STAFF RECOMMENDATION
319 South Seventeenth Street
August 19, 2015

Application: New construction-addition
District: Lockeland Springs-East End Neighborhood Conservation Zoning Overlay
Council District: 06
Map and Parcel Number: 08314027500
Applicant: Craig Kennedy, Bootstrap Architecture
Project Lead: Paul Hoffman, paul.hoffman@nashville.gov

Description of Project: A rear screened porch and rear addition that is wider on one side than the existing contributing house.

Figure 3. Front elevation. The proposed addition extends to the side and above the existing ridge line.

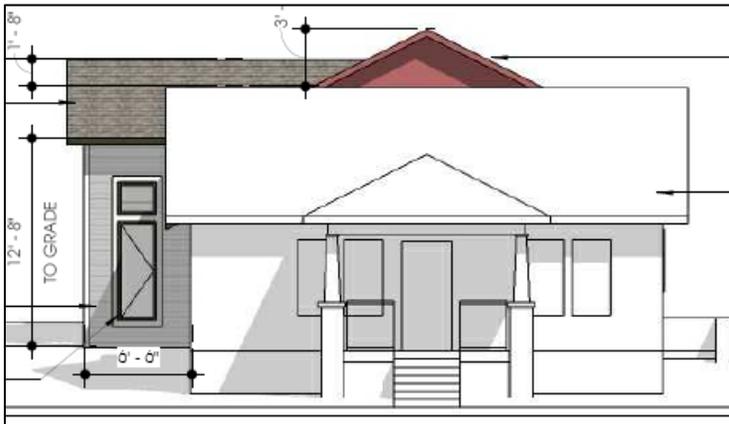
Height & Scale: The rear screened porch measures twenty-five feet (25') across, and ten feet, ten inches (10'10") deep. The proposed addition has a footprint of one hundred and five square feet (105 sq. ft.). It extends six feet and six inches (6'6") from the left side of the house. At only twenty-eight feet (28') wide the house is narrow enough to meet the conditions of the design guidelines that allow for additions to extend beyond the sidewall of the house. However, wider additions have typically been required to be lower in height than the existing house and narrow in width to assure that they are subordinate. The proposed addition is one foot and eight inches (1'8") taller than the ridge of the house. The proposed eave height of twelve feet, eight inches (12'8") is higher than the eave height of the house, which is approximately ten feet (10'). Staff recommends that the addition have a ridge height and eave height no taller than the existing ridge height and eave height of the house. With this condition, the project will meet section II.B.1 and 2.

1. The addition's overall height and eave height not be taller than the ridge and eaves of the existing historic building;
2. Staff approve the final details, dimensions and materials of windows and doors prior to purchase and installation.

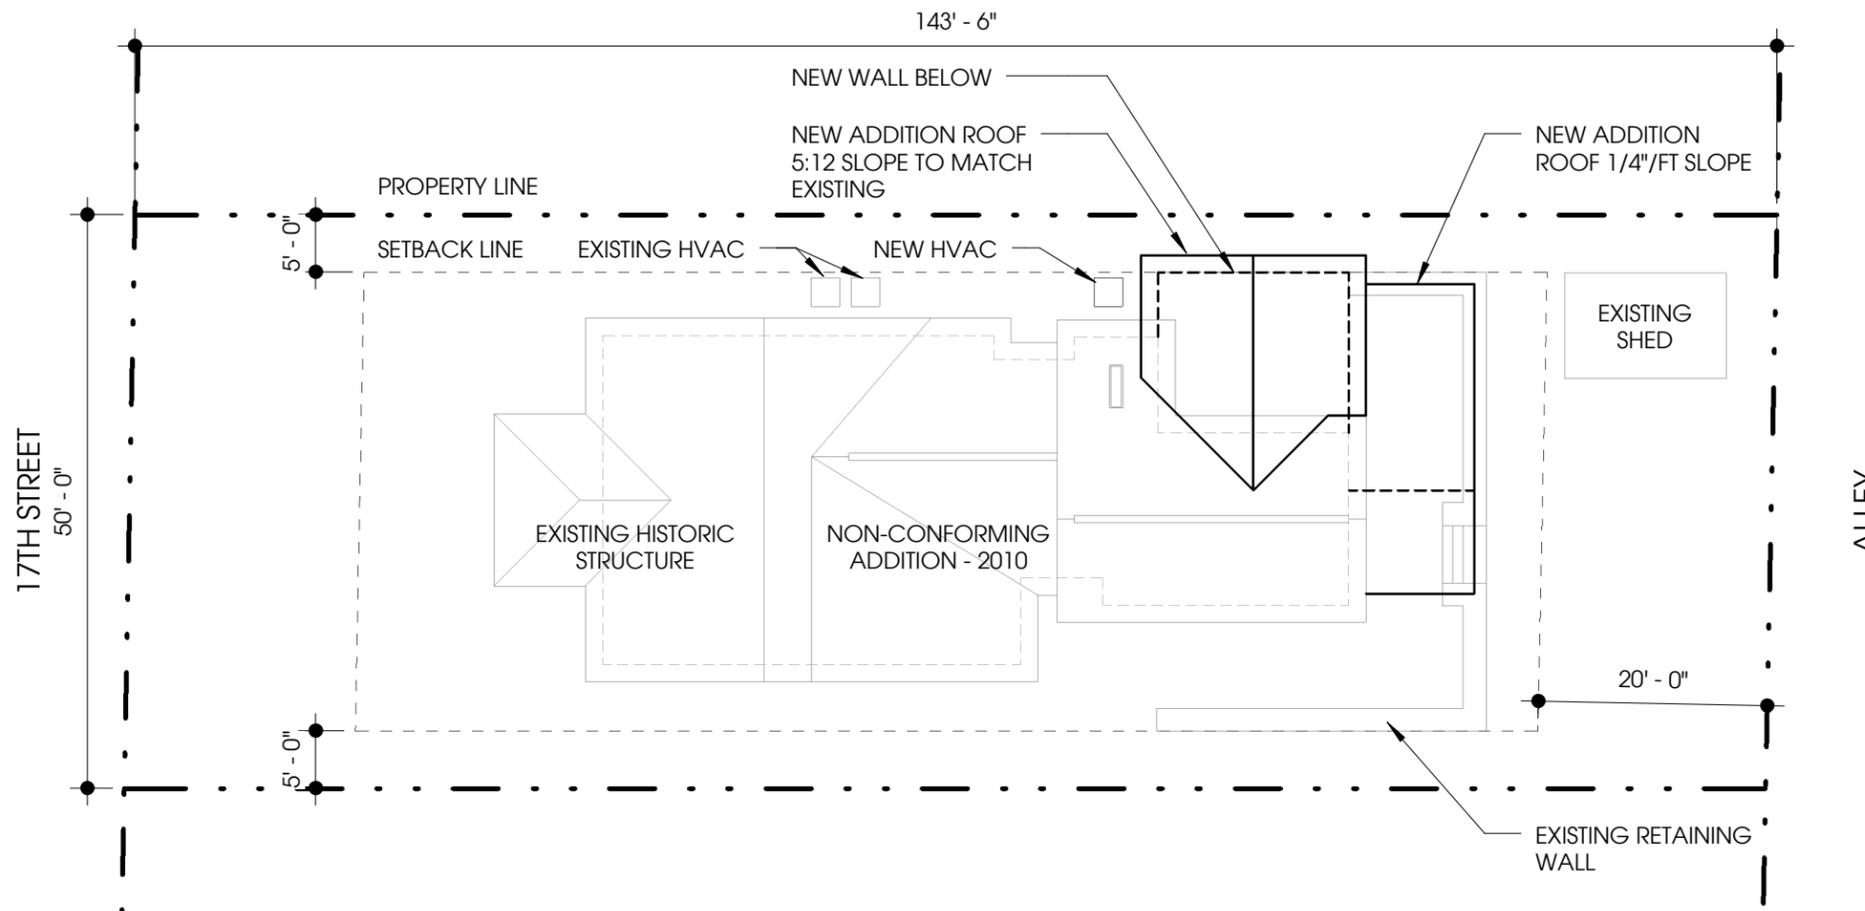
Roof form: The addition has a side-gabled roof form with 5/12 pitch. This is an appropriate roof form as it matches the historic home and is common in the district. The project meets section II.B.1.5.

Proportion and Rhythm of Openings: No changes to the window and door openings on the existing house were indicated on the plans. The windows on the proposed addition are all generally twice as tall as they are wide, meeting the historic proportions of openings. There are no large expanses of wall space without a window or door opening. Staff finds the project's proportion and rhythm of openings to meet Section II.B.1.7.
